Staff Report & Recommendation

Design Review Board

SUBJECT: DRB18-0309
5860 North Bay Road

An application has been filed requesting Design Review Approval for the construction of a new two-story residence on a vacant site, including one or more waivers and a variance to exceed the maximum height for a one-story accessory structure in the rear yard.

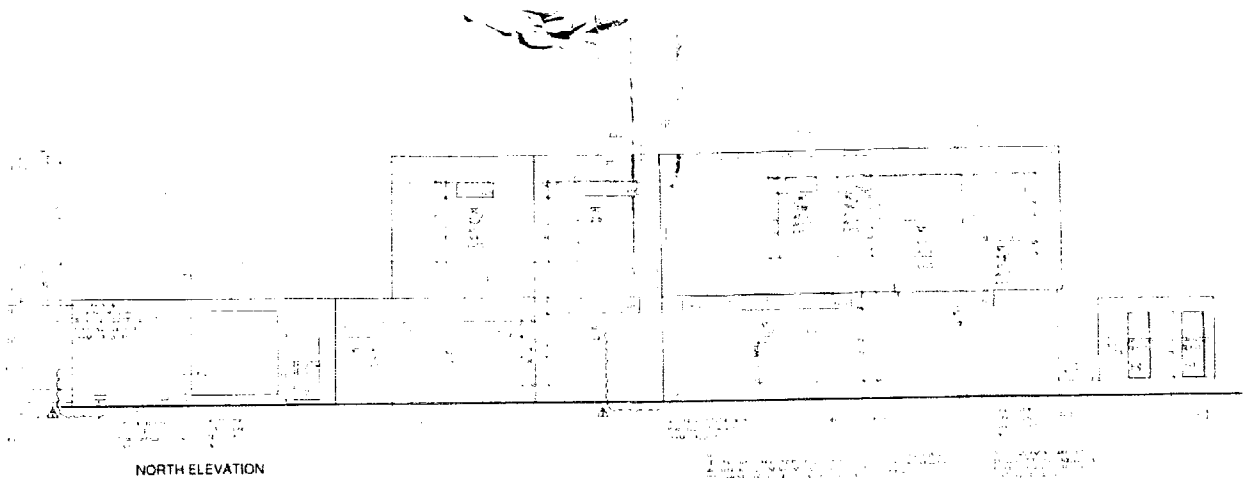
The applicant is proposing to construct a new two-story residence on a vacant waterfront parcel. The proposed design seeks two variances and three design waivers as part of this application. The first floor elevation of the new residence is proposed at base flood elevation (8' NGVD) plus a minimum free board of one foot (+9' NGVD).

The first design waiver pertains to the second floor to first floor ratio. Per the City's Code, when the lot coverage exceeds 25%, the second floor is restricted in massing to 70% of the first floor, unless a waiver is granted by the Design Review Board. As proposed, the home has a second floor to first floor ratio of 105%. In reviewing such waiver requests, staff considers several factors that include design, lot coverage and overall building massing. The home's proposed lot coverage relies on a large central entrance courtyard towards the overall number, which leads to massing being shifted towards both side portions of the residence. Staff is supportive of the additional design waivers for both side open space requirements and increase height for RS-3 zoned properties (see forthcoming analysis), this coupled with a larger than allowed second floor massing, staff finds that the design will impact neighboring properties. As such, staff does not support the requested waiver.

The applicant is also requesting two waivers of the open space requirement for two-story elevations that exceed 60'-0" in length without incorporating additional open space, for both side (north and south) elevations. The solid continuous portion of the north elevation spans 113'-6" in length and is broken up with an approximately 25'-4" wide and 9'-0" deep recess. The recess has been designed flush with the elevation of the first finished floor of the residence, or at 9' NGVD, and is configured with a passive water reflecting feature. As

designed, the proposed open space does not meet the open space requirements as it is not “100% open to the sky” from the ground up, yet is surrounded on three sides. While the resulting open space is higher than adjusted grade and is not landscaped, it does satisfy most of the regulation’s criteria and is consistent with the intent of the ordinance since the designated open space successfully breaks up the massing of the two-story elevation, and does not count towards the lot coverage of the site. Staff is supportive of the design waiver along the north side elevation and maintains the approval will not have an adverse impact on any abutting property since it directly abuts a 25’-0” unimproved right-of-way.

- b. The 70% limitation for the second floor volume **shall not** be waived as proposed; the architect shall either reduce the massing of the second floor to comply with the percentage allowance or reduce the footprint to less than 25% lot coverage.

- c. All required yards shall comply with the minimum yard elevations.
- d. The (north) side open space requirement **shall** be waived as proposed.
- e. The (south) side open space requirement **shall** be waived as proposed.
